Donnybrook JV Pty Ltd

Expert Buffer Assessment

960 Donnybrook Road, Donnybrook

October 2020

Figure 11 Phillips Quarry – Extent of Blast Generated Dust Buffers

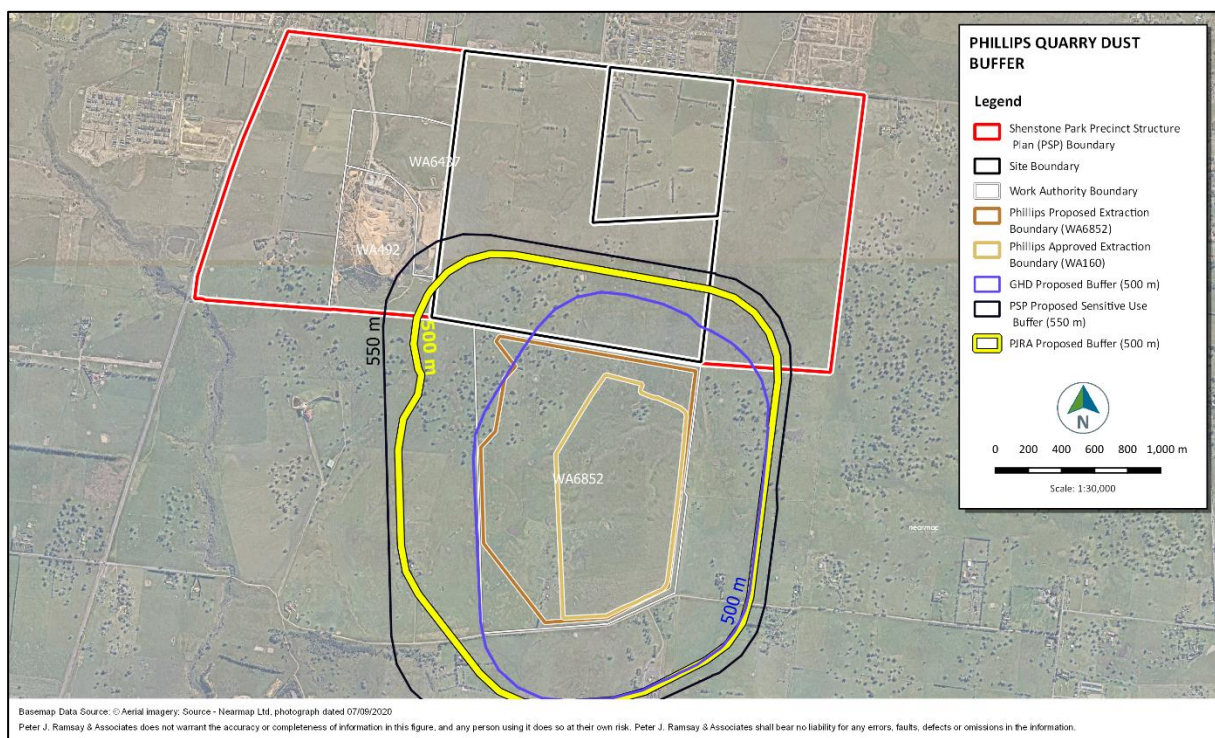
Both GHD (2019) and I consider the use of a 500 m buffer from the approved extraction boundary to be appropriate to provide protection against blast generated dust impacts.

Figure 12 Phillips Quarry – Extent of Blast Generated Fly-Rock Buffers

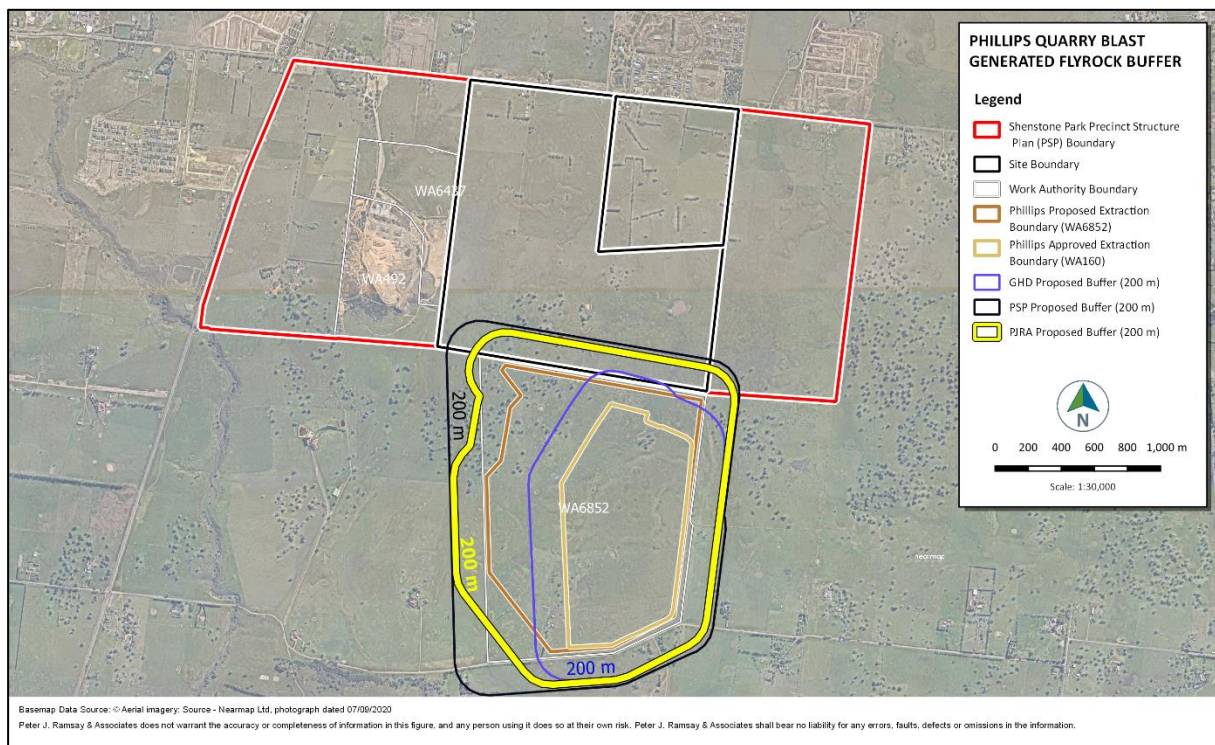
In the Impact Assessment Report (GHD 2017), GHD recommends a 200 m separation distance for protection against blast generated fly-rock. This was adopted in Plan 15 of the original PSP dated September 2019 and retained in Plan 15 of the revised PSP dated October 2020.

I consider the adoption of a 200 m buffer from the proposed extraction boundary within WA006852 to be appropriate to provide protection against blast generated fly-rock impacts.

500 **Figure 13 Summary of Recommended Separation Distances**

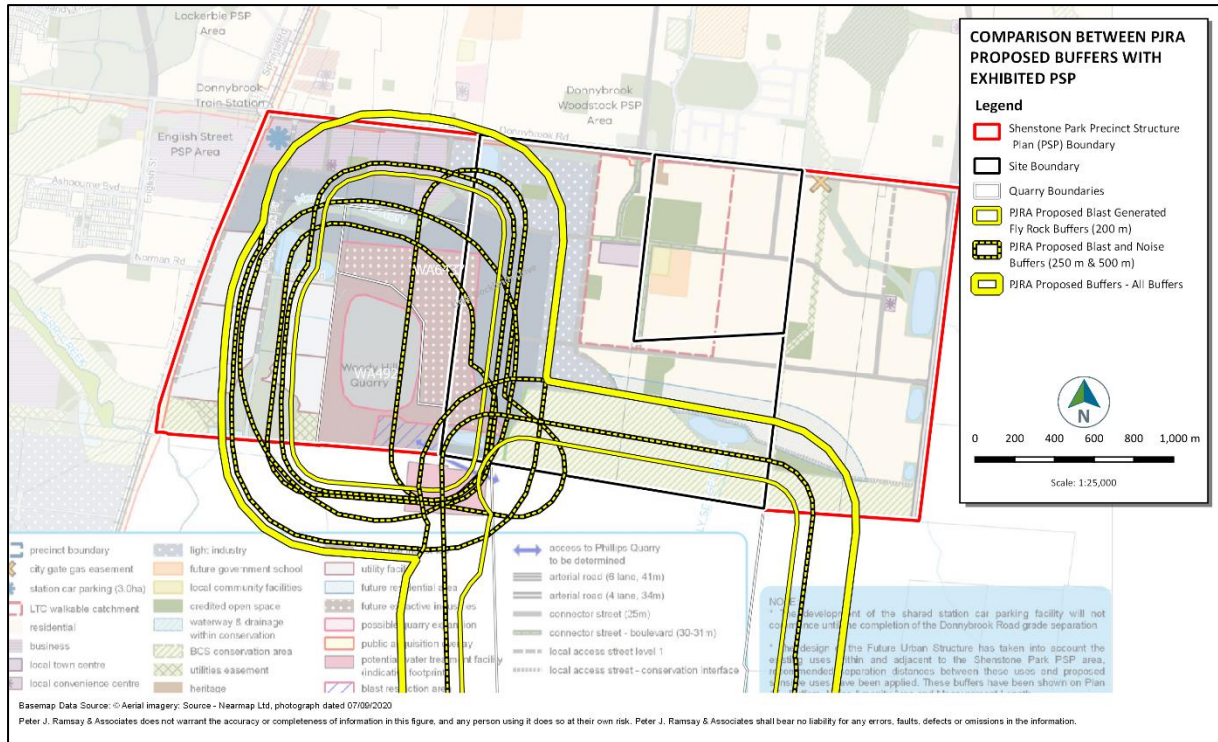
In accordance with EPA Publication 1518 separation distances should be measured from the relevant activity area. In the case of impacts associated with blasting and excavation, where reliable information is available regarding the areal extent of such works, then the separation distances should be measured from this extent.

The findings are not in accordance with the recommended separation distances between hard rock quarries using blasting techniques in similar geology, that have been applied in other recent situations where a separation distance has been put in place.

The extent of these separation distances is shown on **Figure 13** below.

503 **Figure 14 Summary of Recommended Separation Distances on Exhibited PSP**

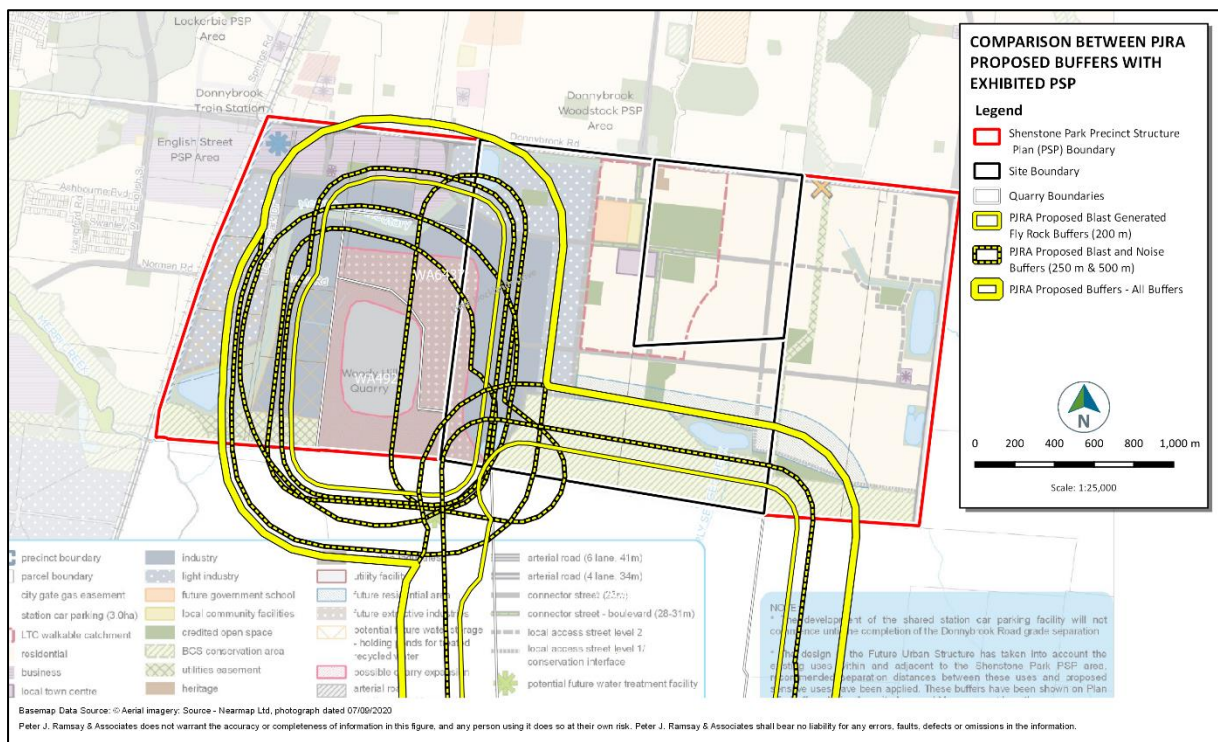
501 The buffers do not align with the interface land uses proposed in the initial PSP, shown in **Figure 14**; or
 502 to the land uses proposed in the revised PSP which are shown in **Figure 15**.
